METROPOLITAN GOVERNMENT OF NASHVILLE AND DAVIDSON COUNTY

STAFF RECOMMENDATION
1520 Woodland Street
October 17, 2012

Application: New construction—addition
District: Lockeland Springs-East End Neighborhood Conservation Zoning Overlay
Council District: 06
Map and Parcel Number: 08309047100
Applicant: Jeff Casella, architect
Project Lead: Robin Zeigler, robin.zeigler@nashville.gov

<p>Description of Project: Application is to construct a side, open-air, covered dining space.</p> <p>Recommendation Summary: Staff recommends approval of the project finding it to meet Section II.B. of the <i>Lockeland Springs-East End Neighborhood Conservation Zoning Overlay: Handbook and Design Guidelines</i>.</p> <p>Recommendation of this project will provide guidance for future similar requests of open-air additions to commercial buildings. Such applications may be appropriate if: the addition is located on the ground level off a secondary facade, is not located on a street facing side of a building, has a permanent glass wall on the portion of the addition which faces the street, and the front sits back a minimum of three (3') from the front or side wall, depending on placement of the addition. The

SITE PLAN DIAGRAM

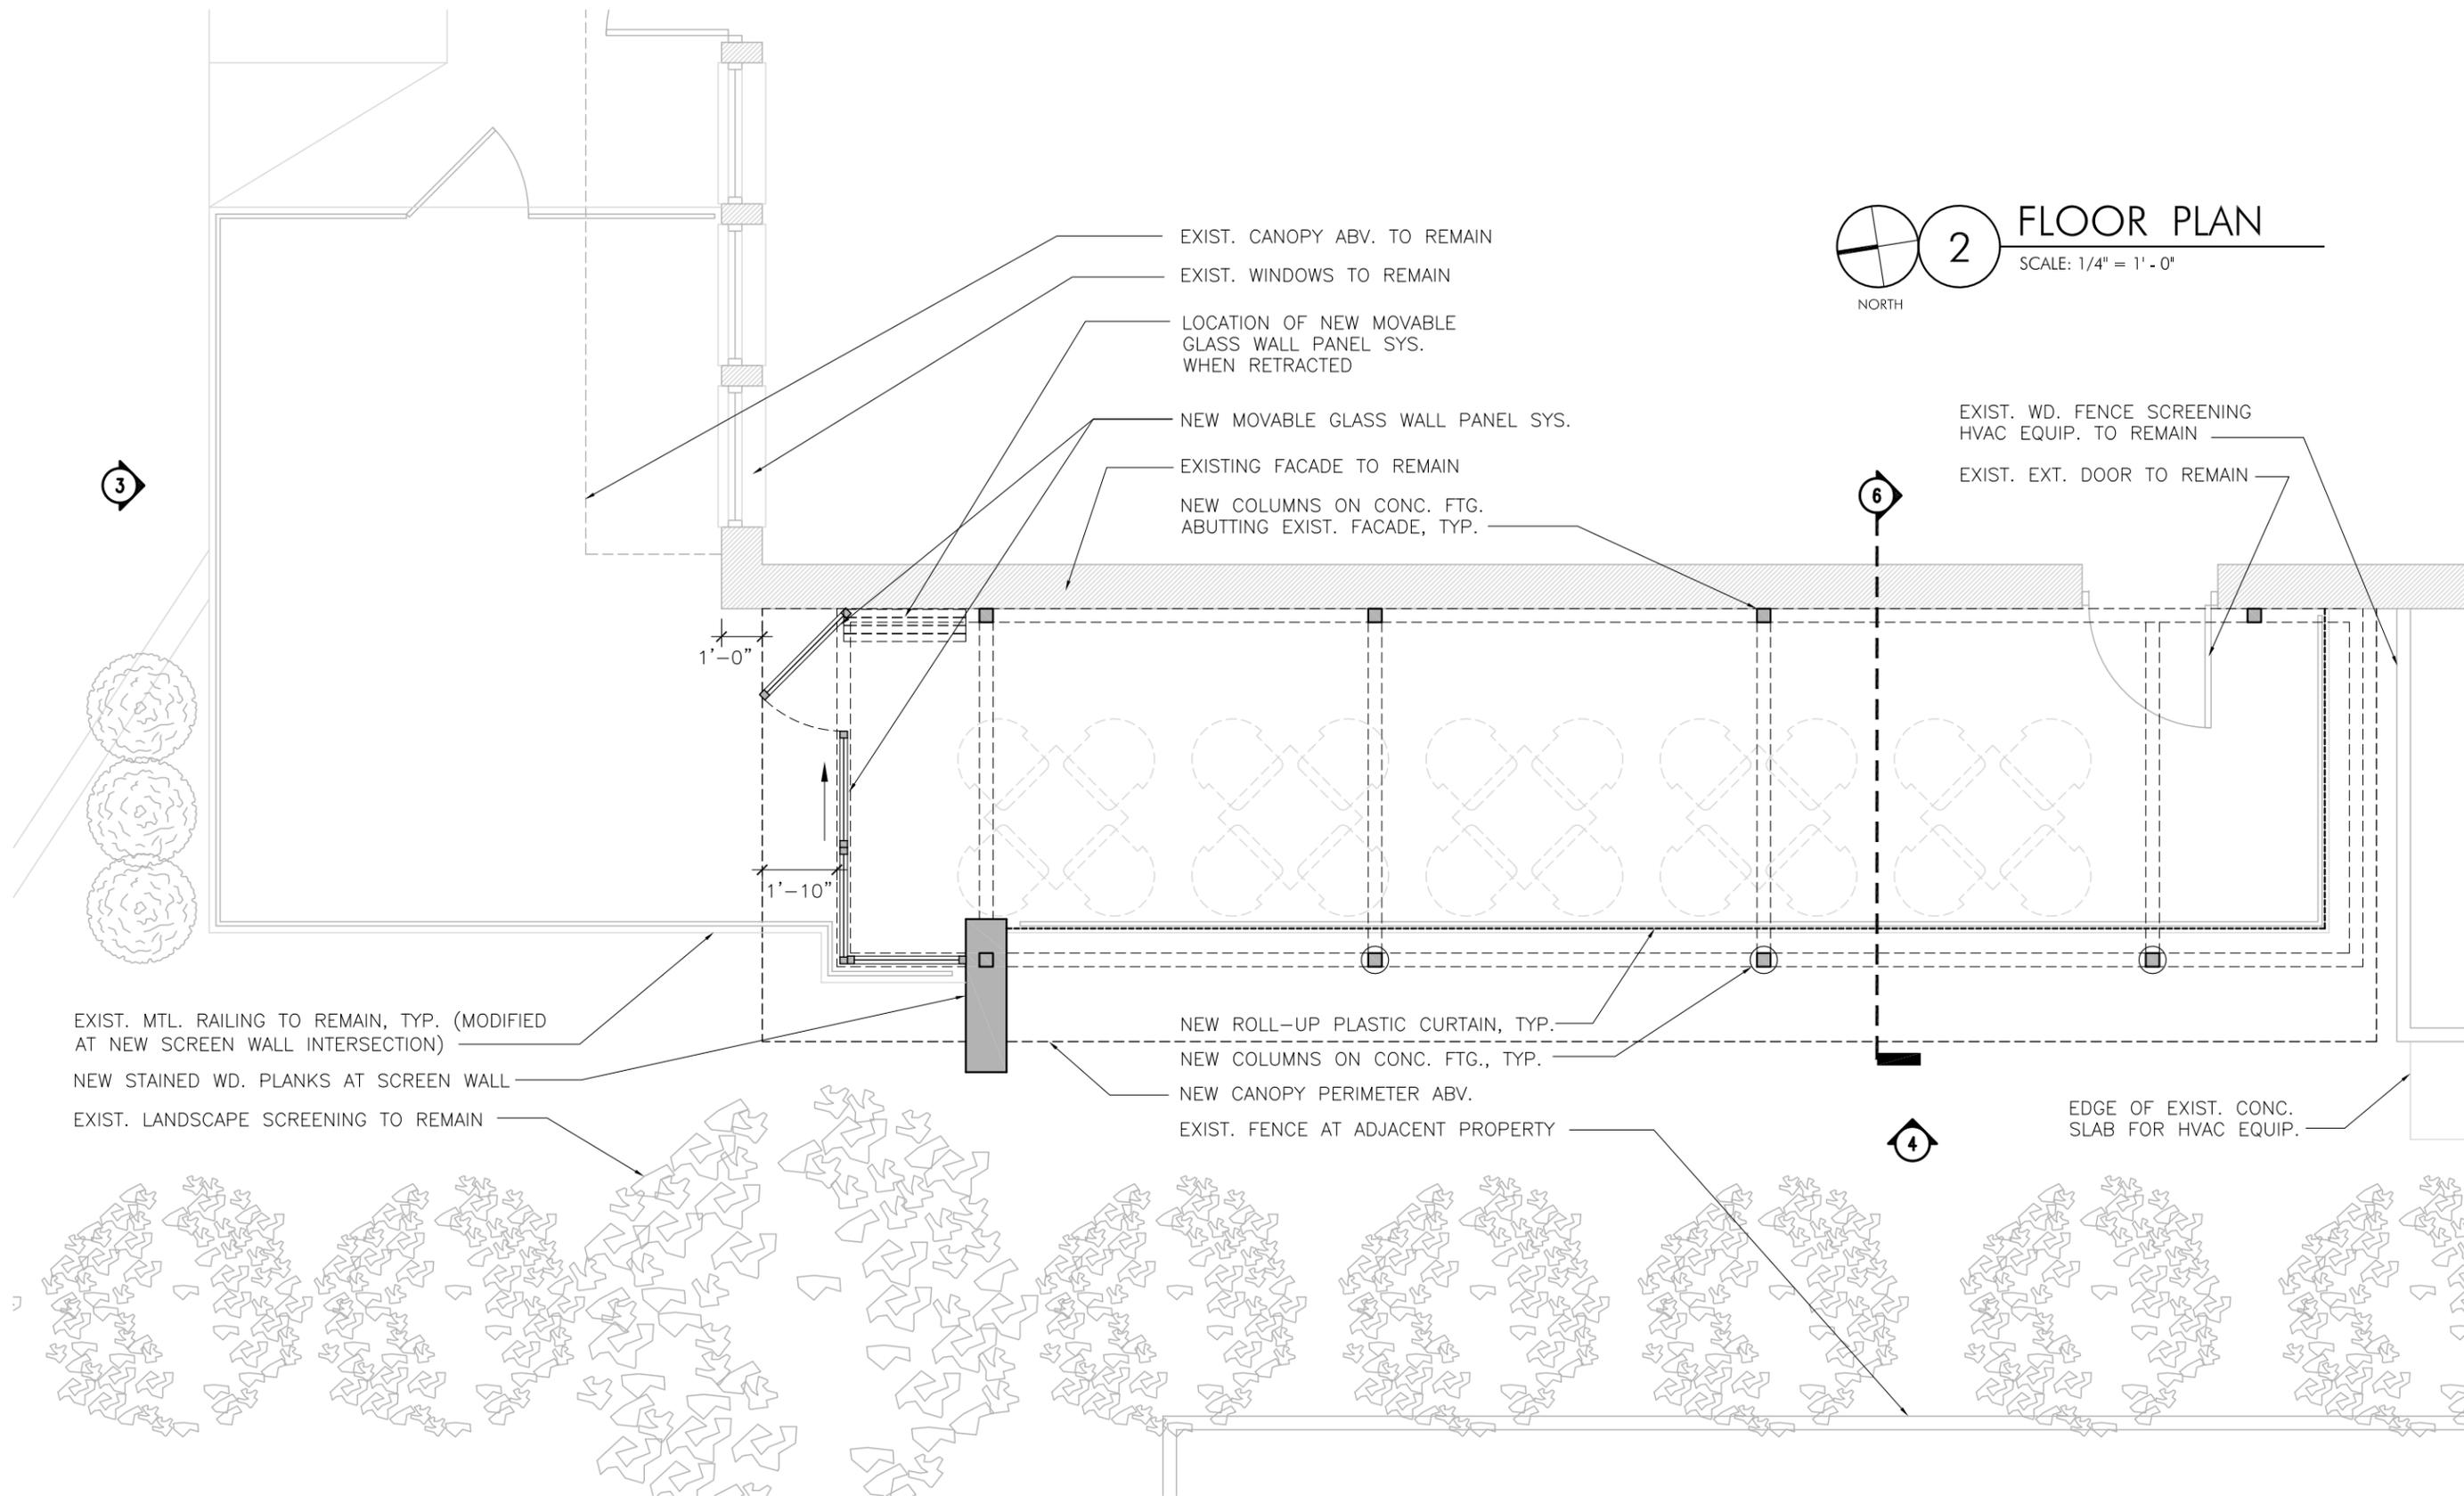
Location and Setback: The building sits off-center on the lot, providing space for the right side patio that exists now. The property is zoned CM and there are no side setback restrictions. Commercial buildings that built from lot line to lot line are historically appropriate so staff finds a right-side extension of this type to be appropriate. A door from the building already exists to access this seating area. Staff finds the location and setbacks of the proposed porch and rear addition to meet Sections II.B.3. and II.B.10. of the *Lockeland Springs-East End Neighborhood Conservation Zoning Overlay: Handbook and Design Guidelines*.

3 NORTH ELEVATION (FRONT)
SCALE: 1/4" = 1' - 0"

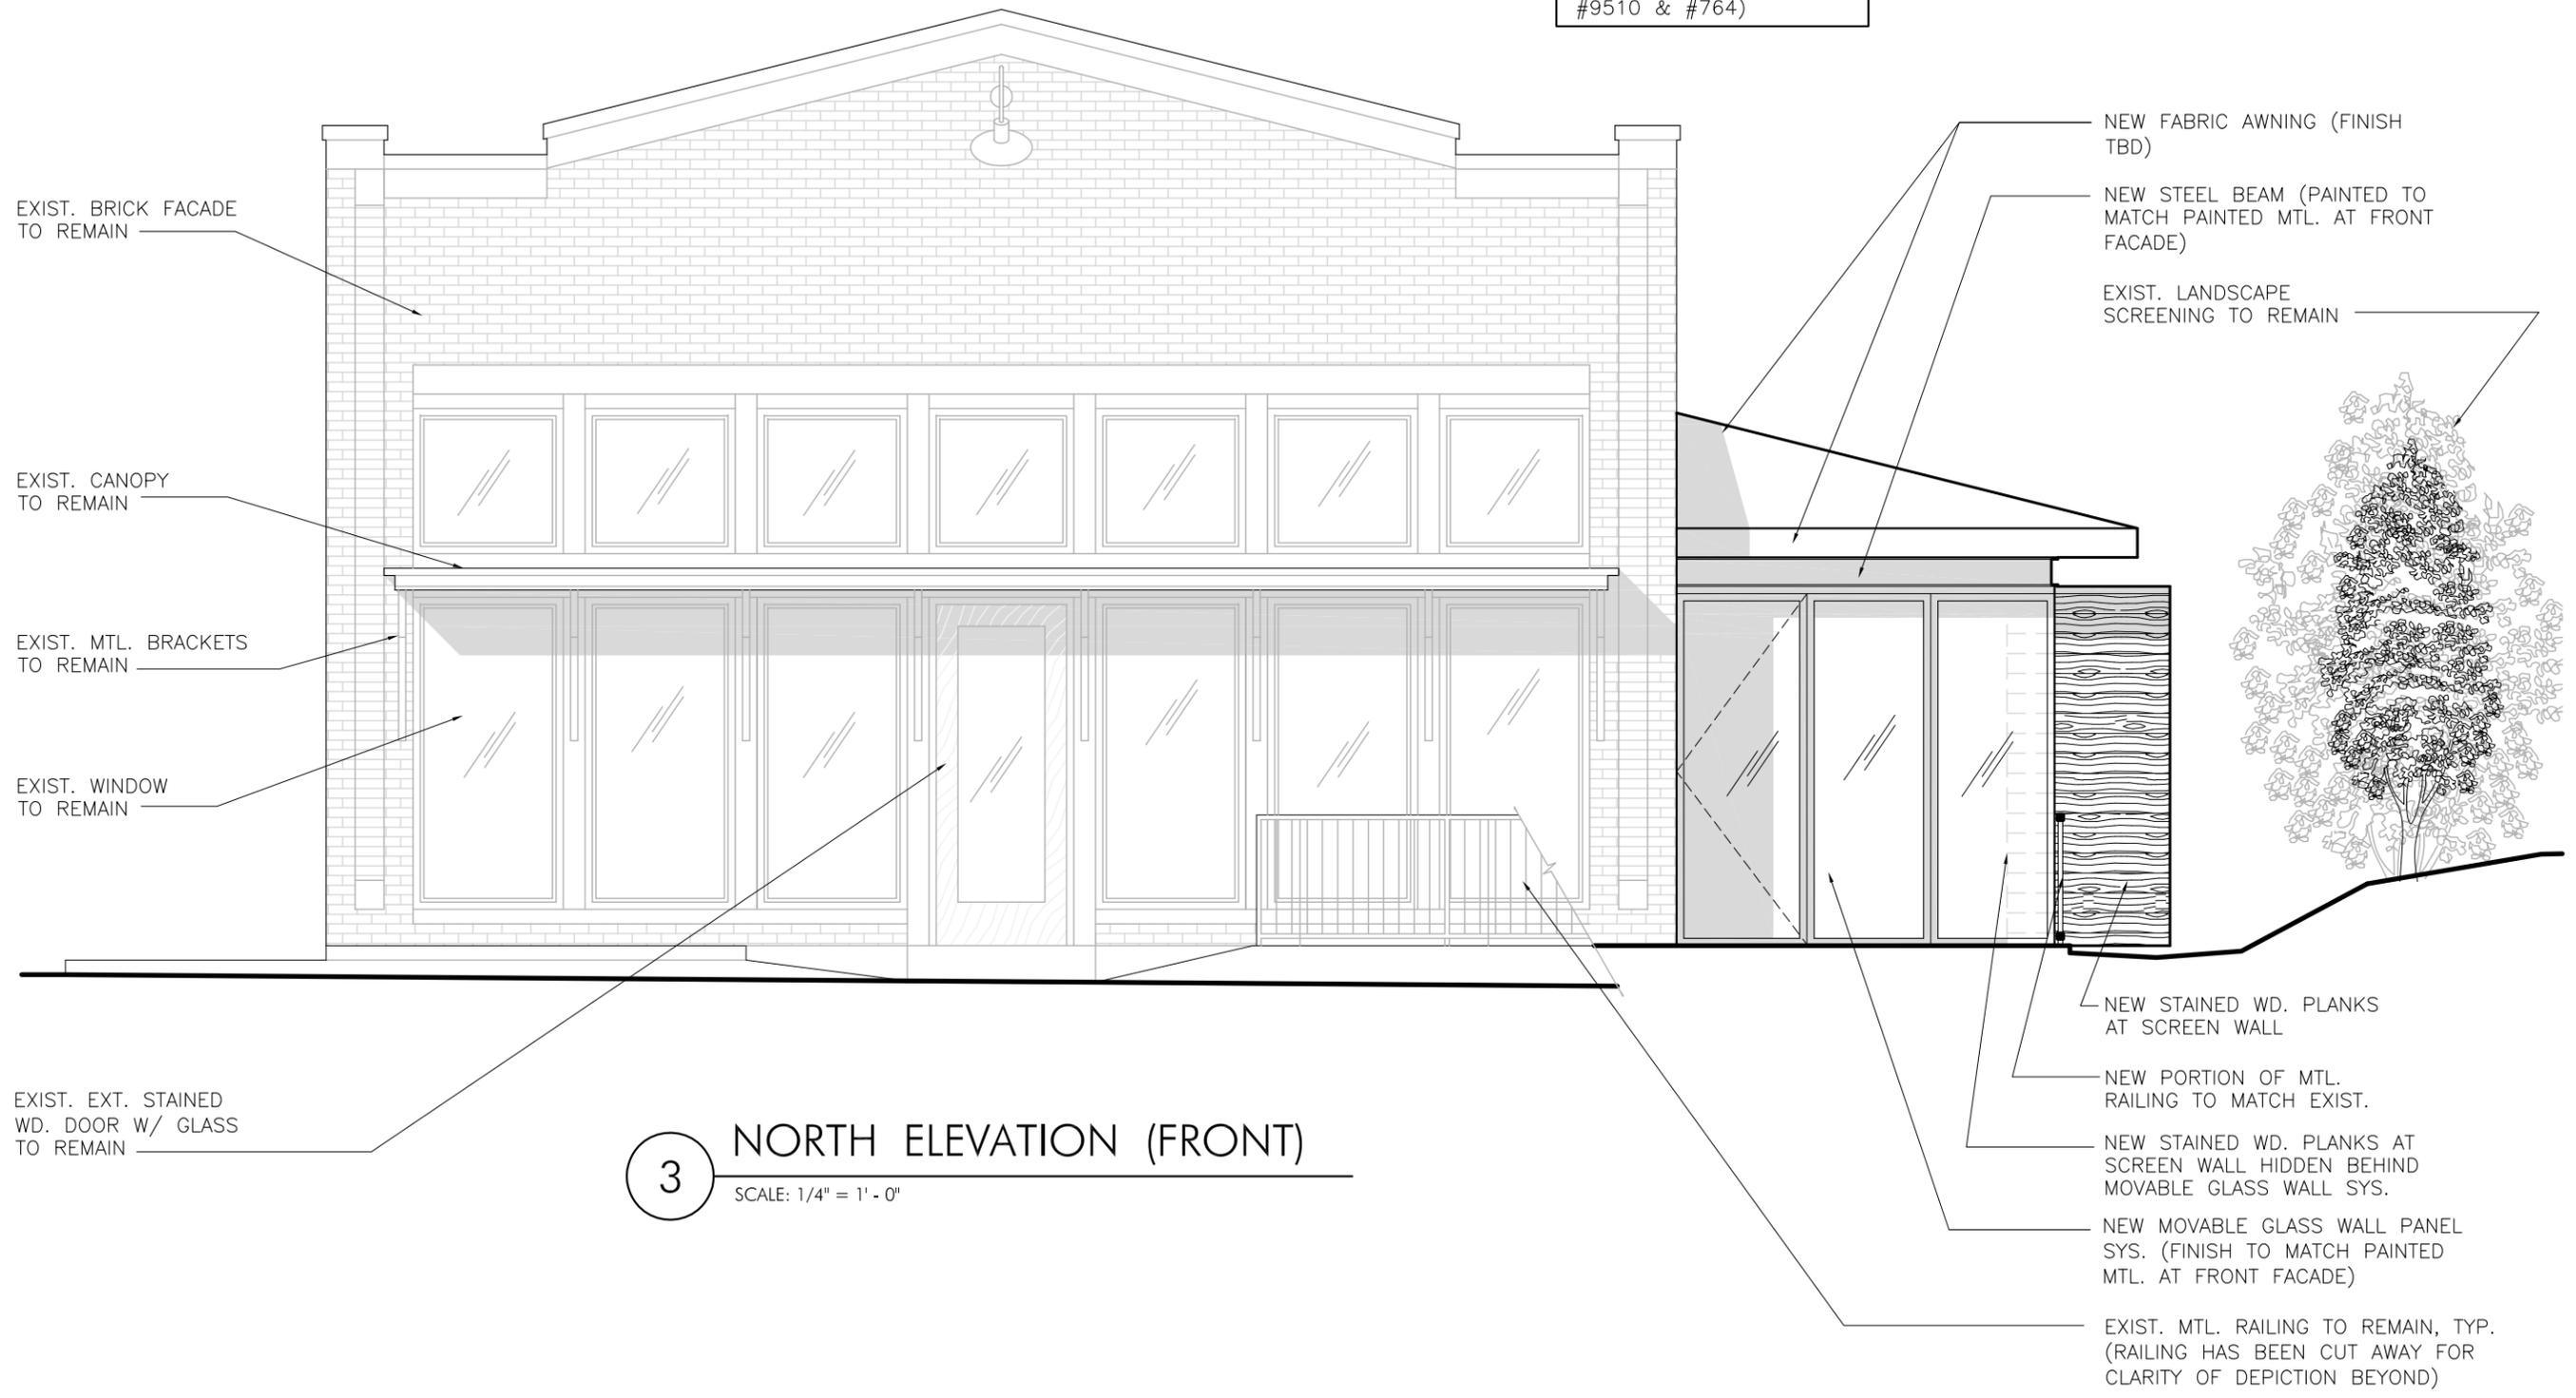
Proportion and Rhythm of Openings: The front façade of the addition will be mainly three full-light doors, which can accordion back to one side in good weather, and a small section of screened wall. The sides and rear of the addition will be open with roll-up plastic sides. The fully open visual quality of the addition is appropriate for a covered area attached to a commercial building.

Materials, Texture, and Details and Material Color: Materials include glass wall panels with a finish that matches the existing storefront, a wood screen, and a canvas covered roof on a steel frame. The sides will have plastic roll-up sides that have been disapproved in highly visible locations for other projects. In this proposal, the addition will appear to have a more permanent front with the glass panels and wood screen that wraps the corner. The plastic sides will be minimally visible on the secondary elevation, when they are down.
